ADDENDUM NO. 1 TO PROJECT NO. 47261

CONSTRUCTION WORK PROVIDE MASONRY REPAIRS, FAÇADE, BUILDING 40 CREEDMOOR PSYCHIATRIC CENTER 80-45 WINCHESTER BOULEVARD QUEENS VILLAGE, NY

January 9, 2026

MARK	DATE	DESCRIPTION
△	01/09/2026	ADDENDUM #1
	10/10/2025	FINAL SUBMISSION
PROJECT NUMBER:	47261 - C	
DESIGNED BY:	NK / KH	
DRAWN BY:	AB / KP / OG / VY	
FIELD CHECK:		
APPROVED:	NK / PM	
SHEET TITLE:	ROOF "M" ENLARGED RESTORATION PLAN	
DRAWING NUMBER:	A-402	
SHEET	67	OF 164

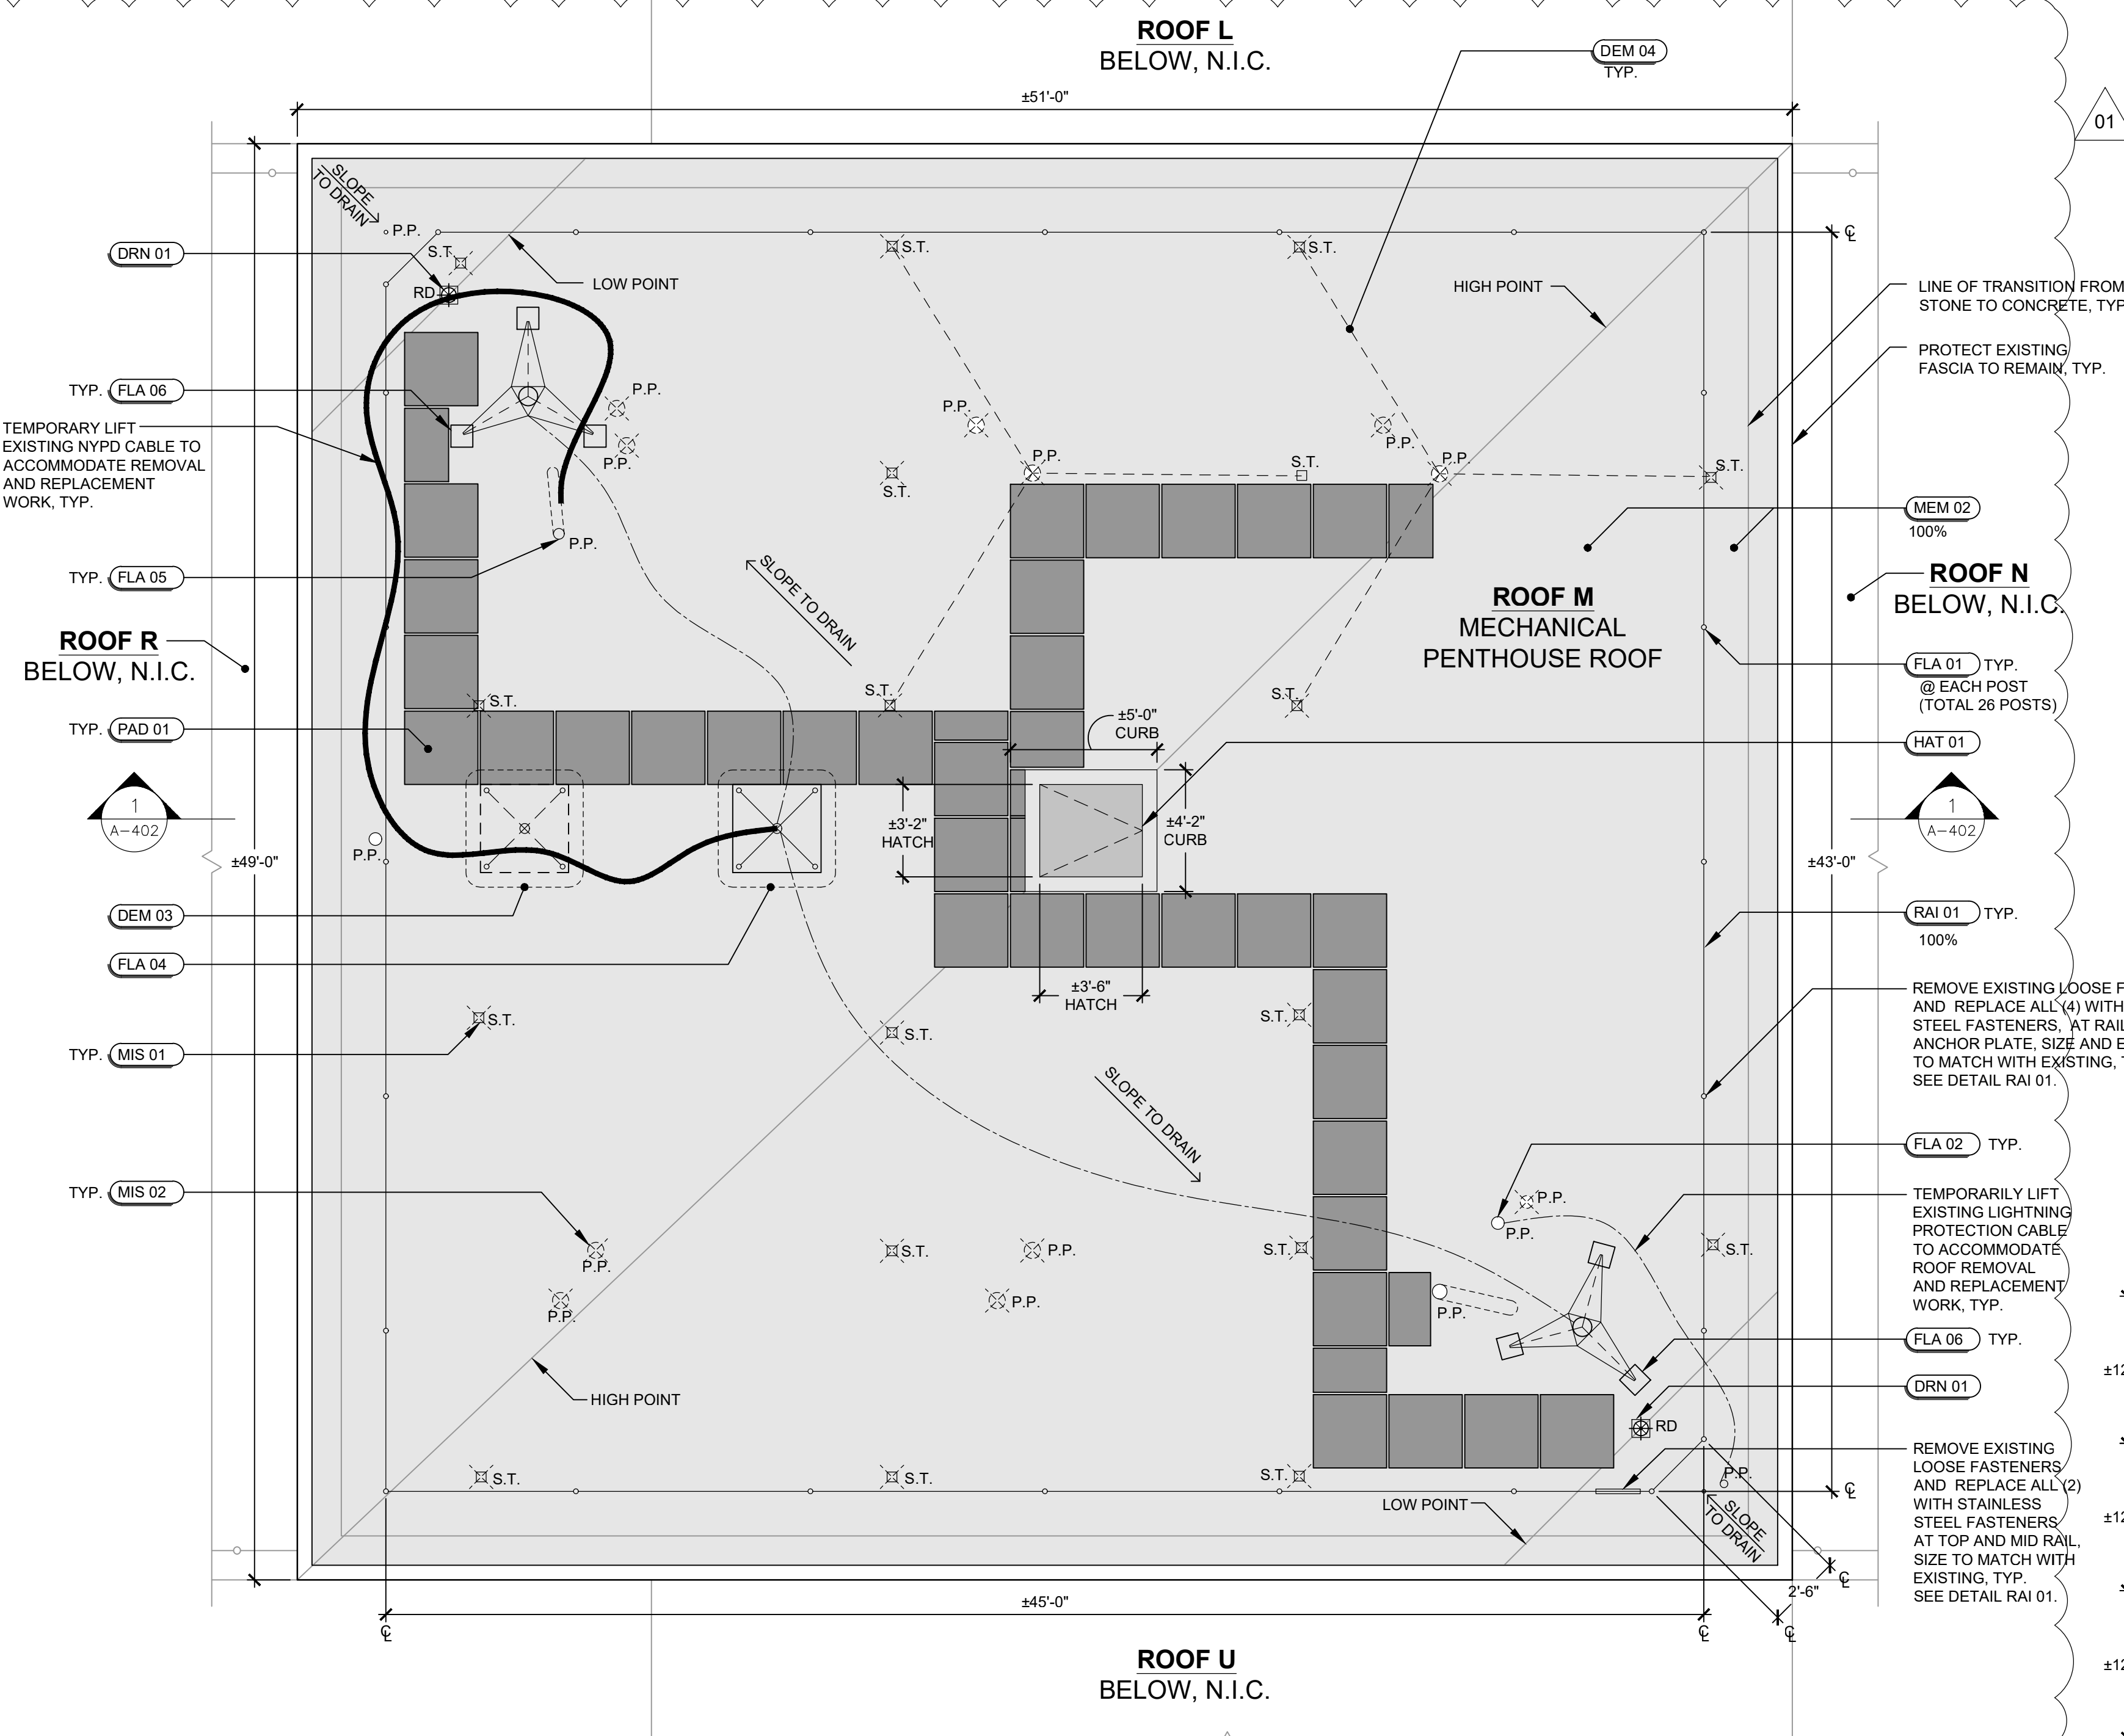
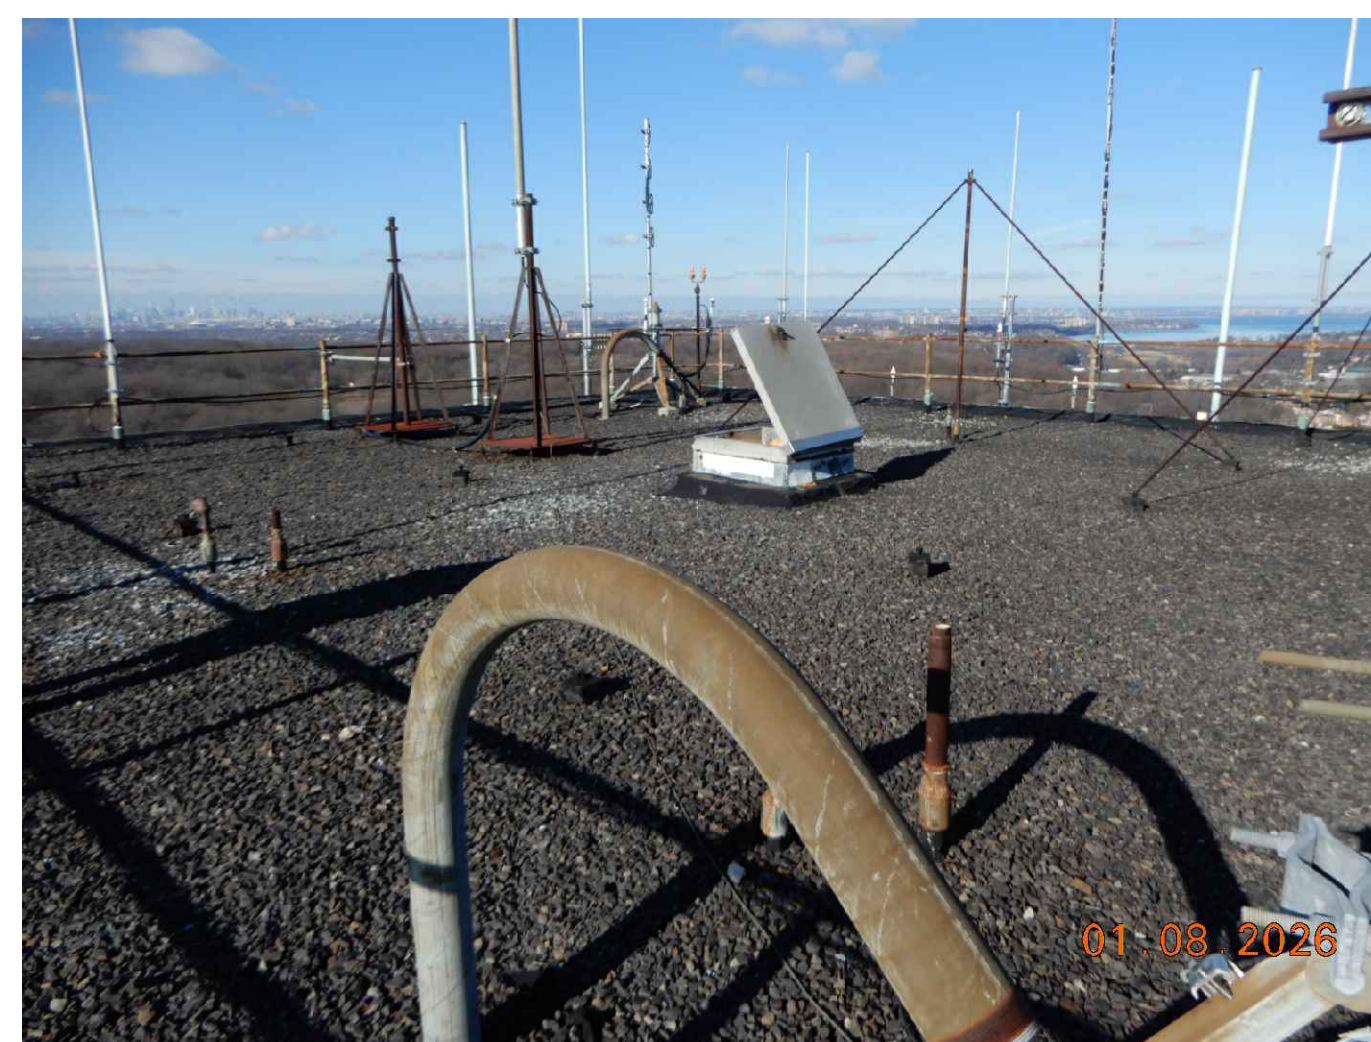
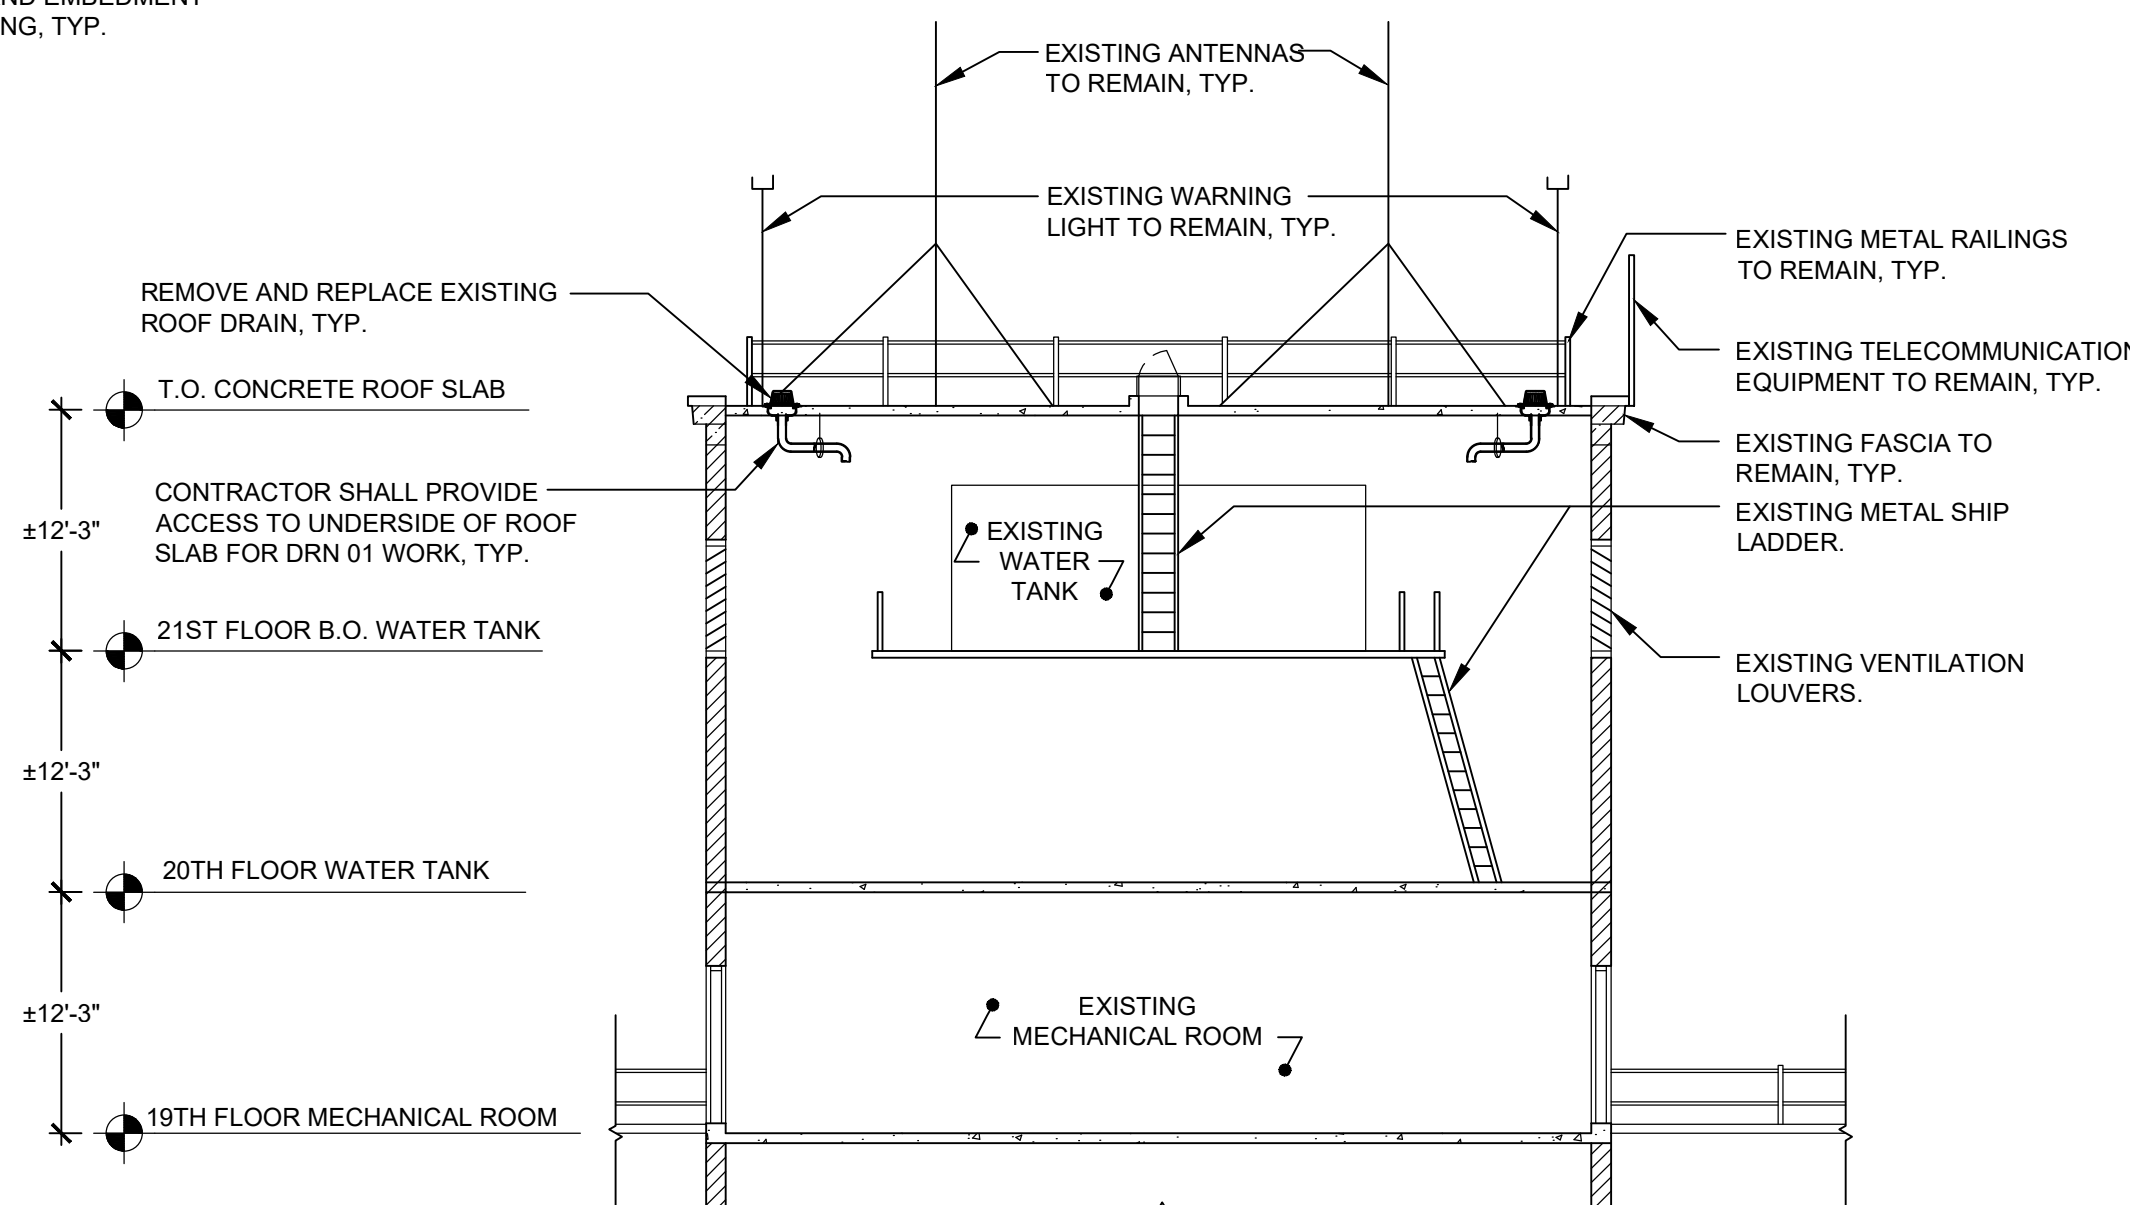
1. Drawing No. G-002
 - a. Delete “APPLICATION OF VAPOR BARRIER ON INTERIOR WALL AT MECHANICAL PENTHOUSE” bullet point from list of Summary of Work in its entirety.
2. Drawing No. G-005
 - a. Detail FLA 03 is omitted.
3. Drawing No. A-402
 - a. Updated Roof M Plan to include details DEM 03 & DEM 04. Included graphics for the NY State cable and lightning protection cable. Removed tag for FLA 03 (omitted). Updated graphics for removal for steel tubes.
4. Drawing No. A-501
 - a. Included details DEM 03 & DEM 04.
5. Drawing No. A-504
 - a. Detail FLA 03 is omitted.
6. Drawing No. A-509
 - a. Included photo of existing cables to be temporarily removed and reinstalled along guardrail.
7. Drawing No. A-539
 - a. Included note of location of traffic coating application.
